Service Bulletin

File GE-10-118

Subject ESA-569 Clutch Plate Super 55

Date 11-16-84

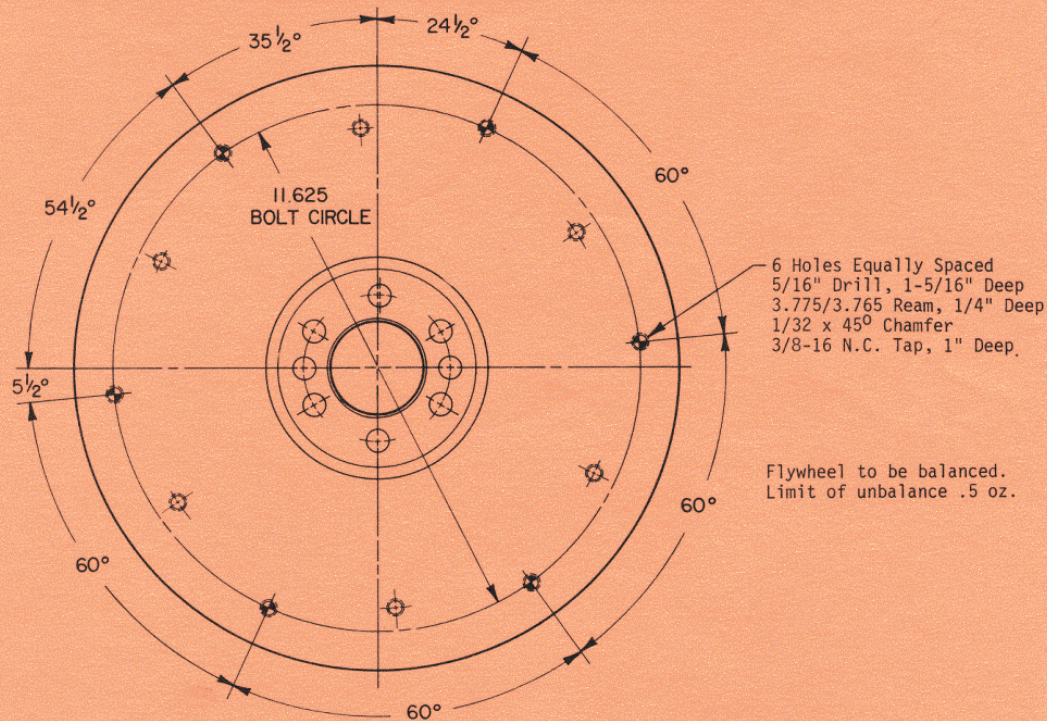
ESA-569 Clutch Plate Assembly (9-inch) has been discontinued by our supplier as a repair part and replaced by 100 691AS Clutch Plate Assembly (10-inch), 100 687AS Driven Plate (10-inch), 6 - K552 Cap Screws and 6 - 920 156 Internal Tooth Lock-washers.

In order to install larger 100 691AS Clutch Plate Assembly, flywheel must have 6 3/8-16 tapped holes in a 11.625 inch bolt circle.

If flywheel does not have these holes to accept new 10-inch clutch, flywheel must be reworked (Fig. 1) or replaced with flywheel that has 11.625 inch bolt circle.
